# The Dog on the Tucker Box Redevelopment

## Addendum to Tree Inventory

January 2024  
Ref. 23/452A.

# Additional Trees on The Dog on the Tucker Box Site, Five Mile, via Gundagai.

### Amended Proposed Development Plans – Demolition and Site Plans

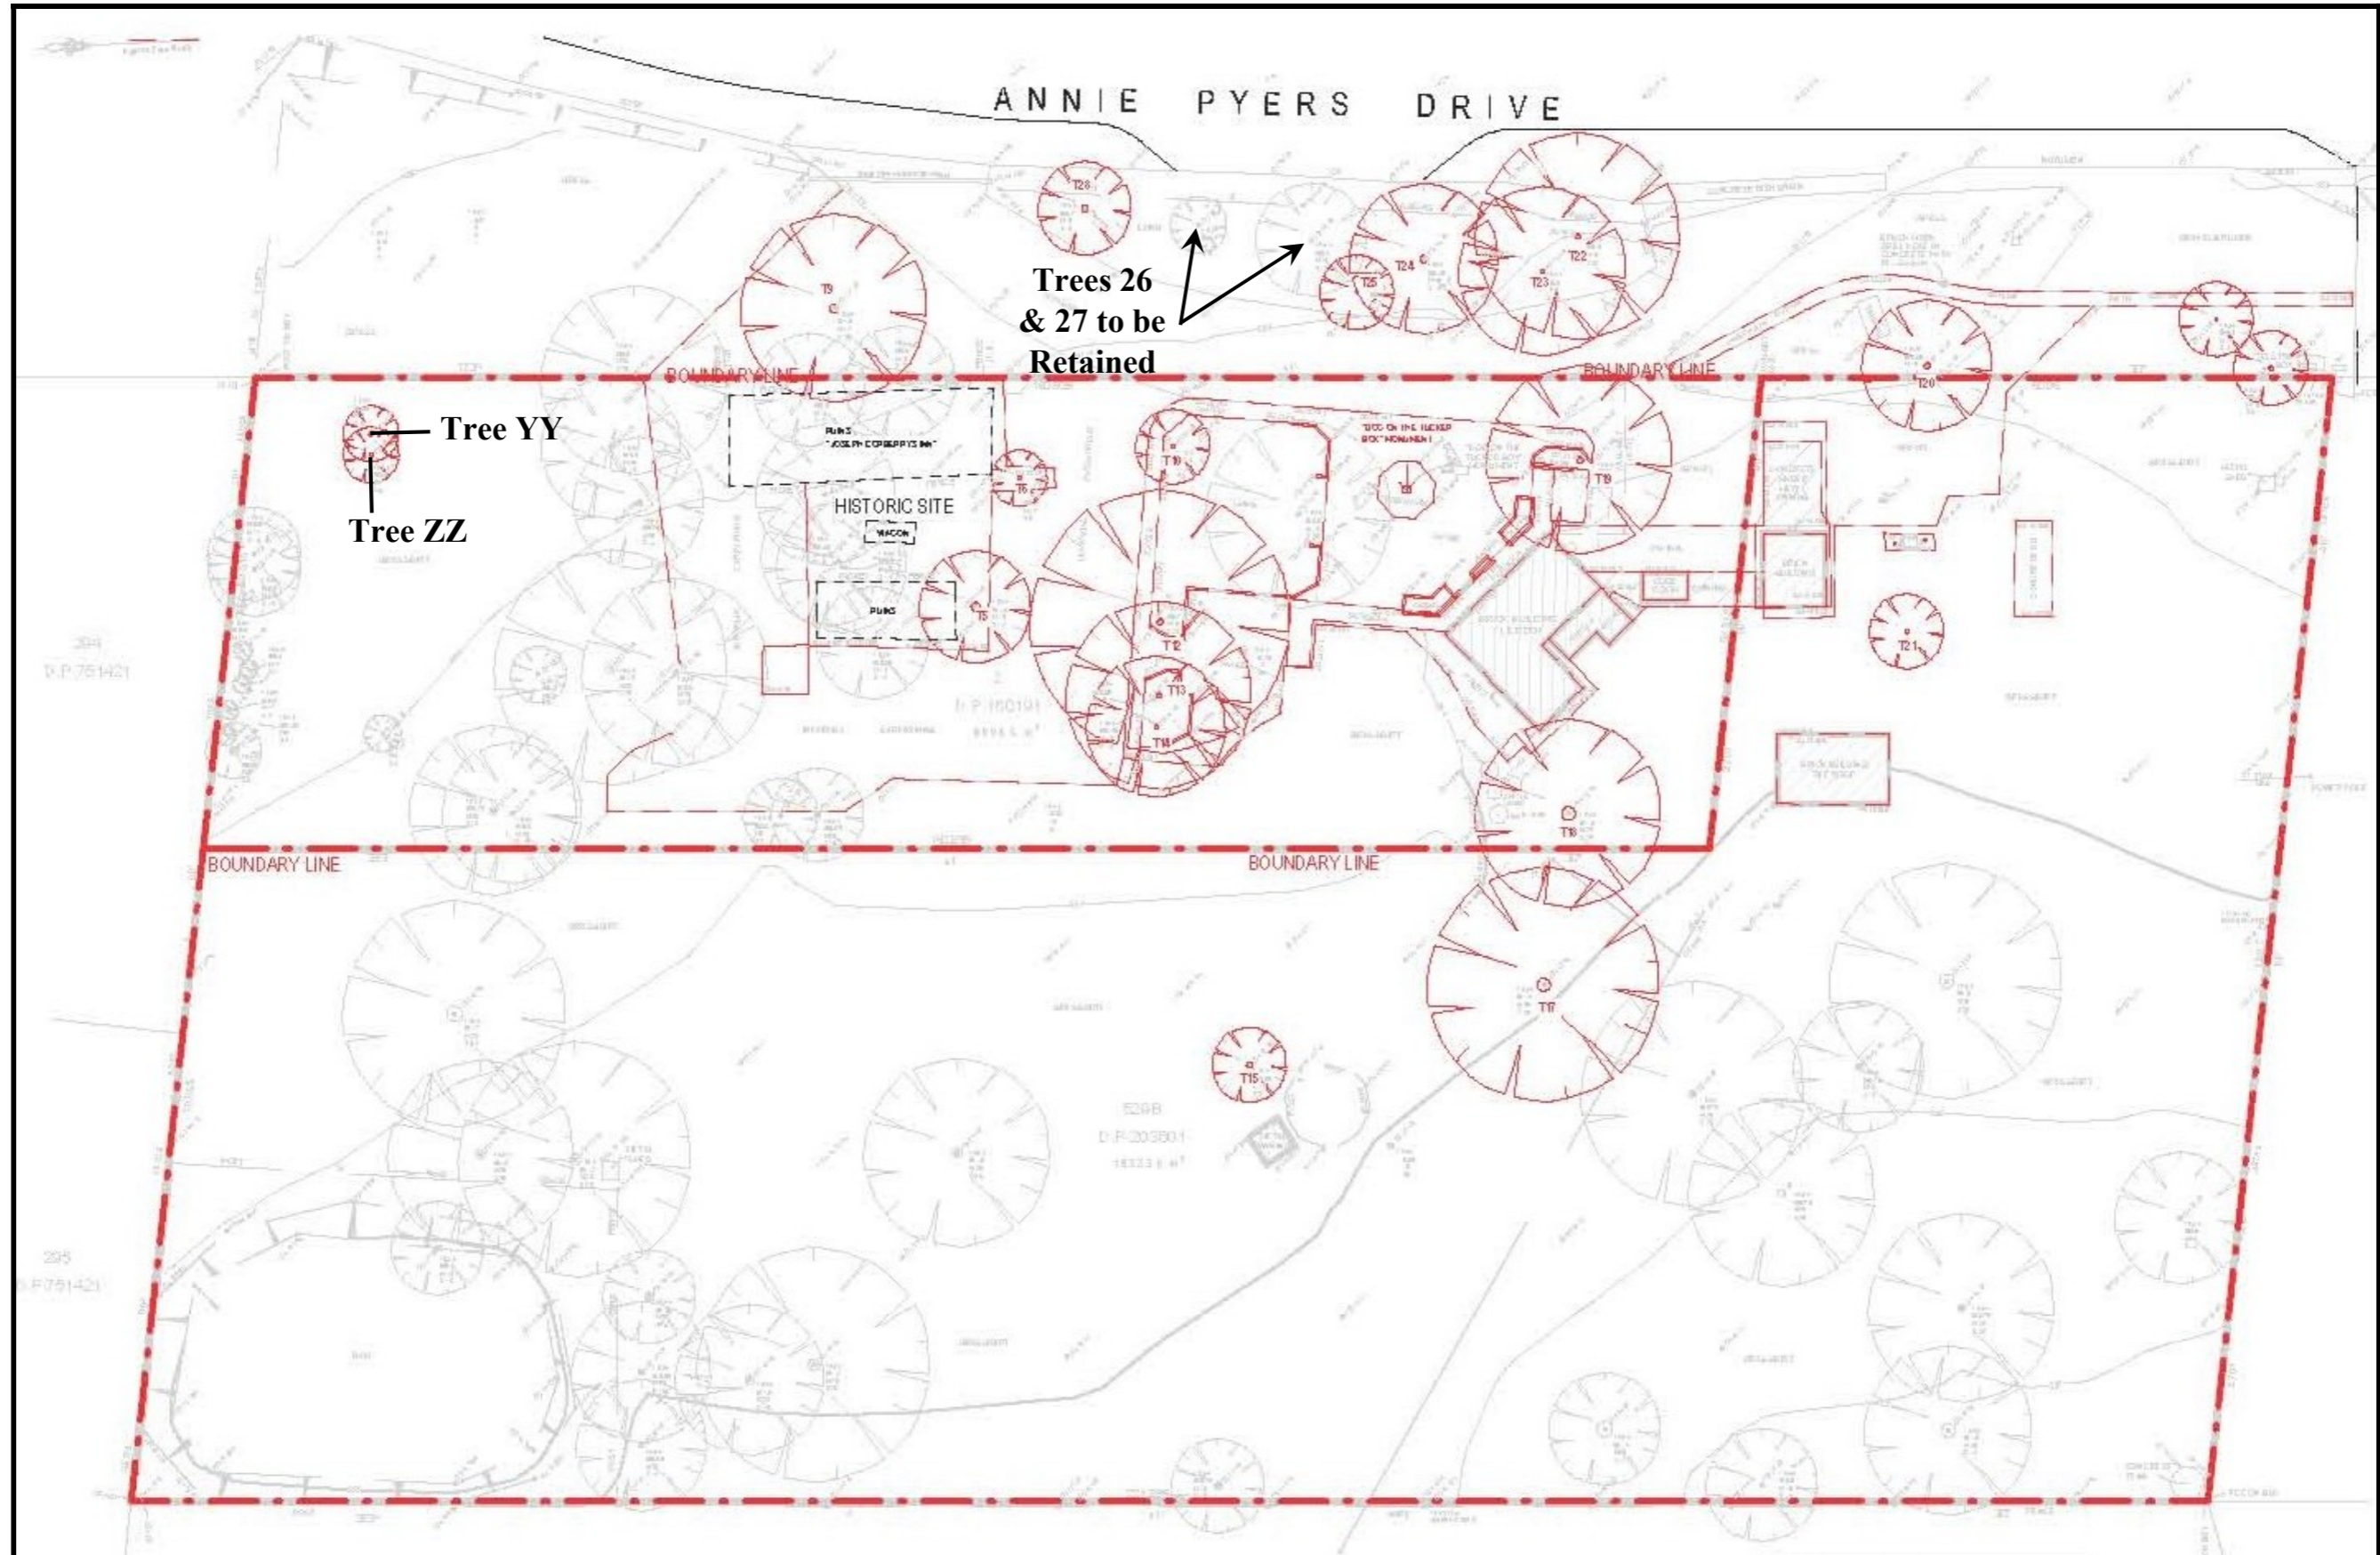
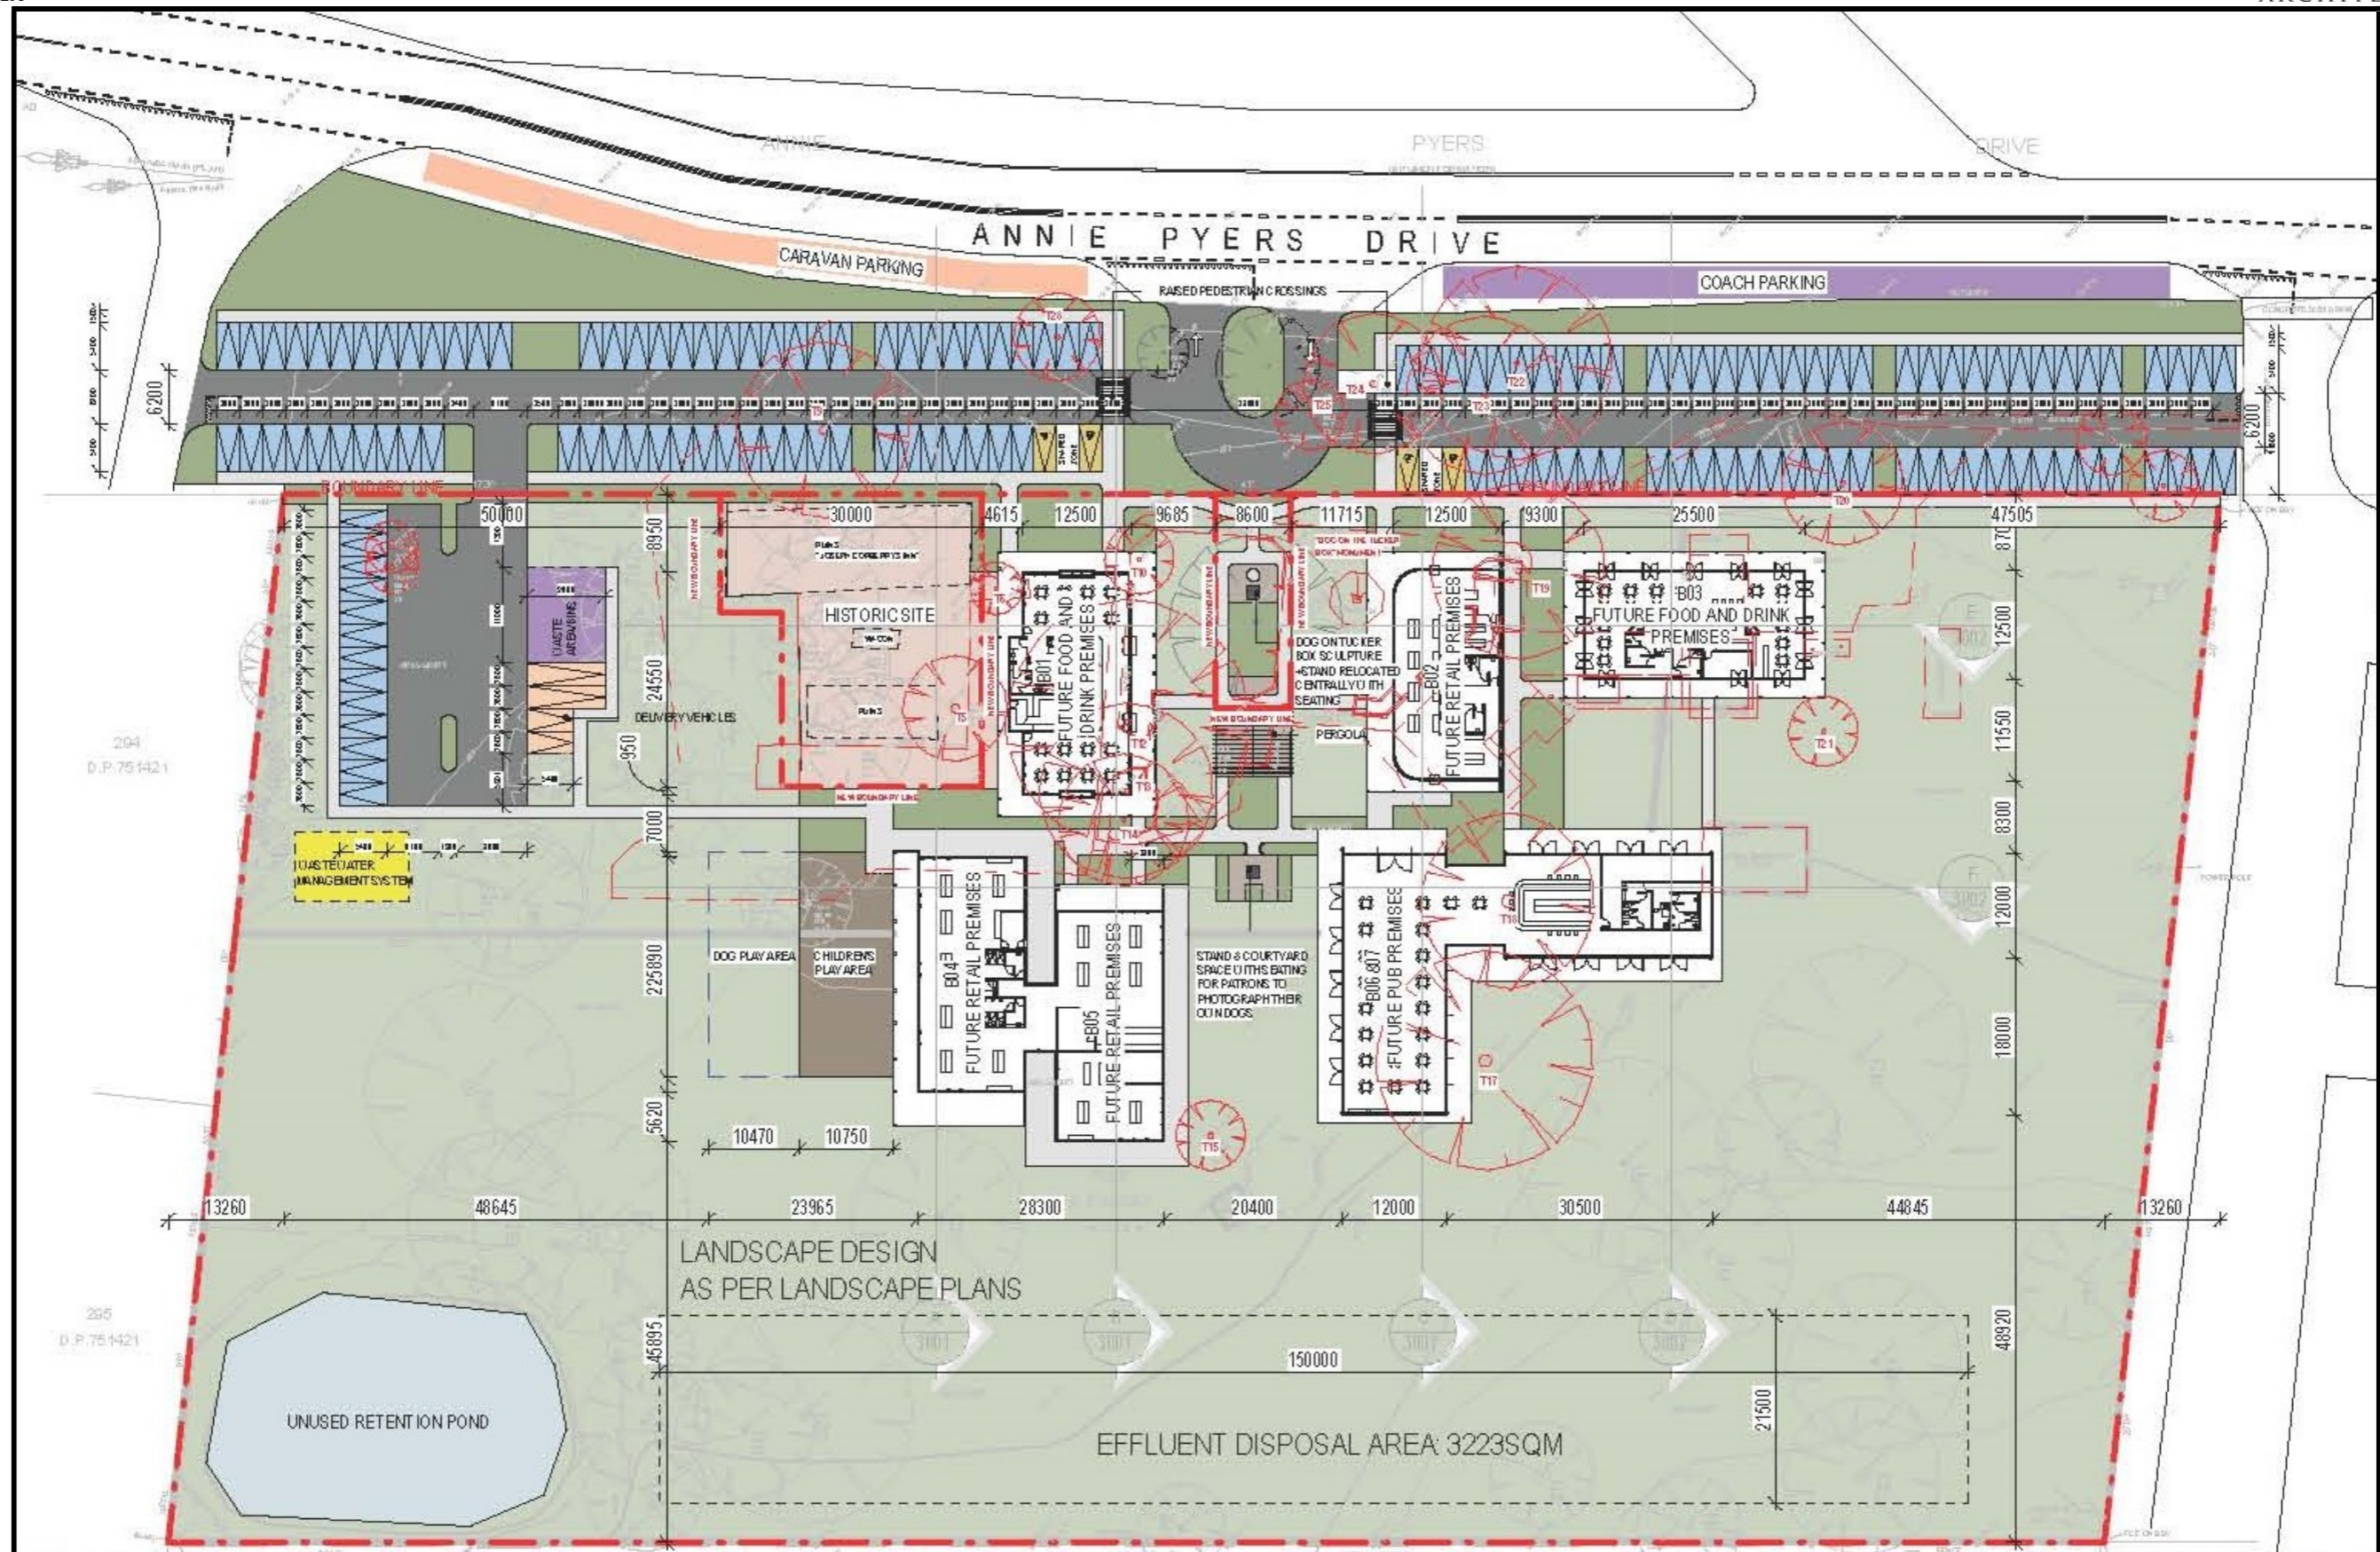
After consideration of the development application documentation for the proposed redevelopment of The Dog on the Tucker Box site the Cootamundra-Gundagai Regional Council requested further information from the project's proponent, leading to design amendments for the proposal. These design amendments altered the trees that will be impacted by the proposal and this Addendum records those alterations.

The additional trees now impacted by the proposal (described as Trees YY & ZZ) have been included on the Table included as Attachment A to this Addendum. This Table also notes that Tree Nos. 26 & 27 will now be retained on the site. Attachment C includes a photo of the two additional trees (sourced from Google Streetview) and of the two trees now proposed to be retained. Amended Development Design Drawings are included as Attachment B to this Addendum.

As tabulated in Attachment A and shown in Attachment B, the number of trees are to be removed to facilitate the proposed mixed use commercial development and its ancillary parking provision within Annie Pyers Drive road reserve remains at twenty-four.
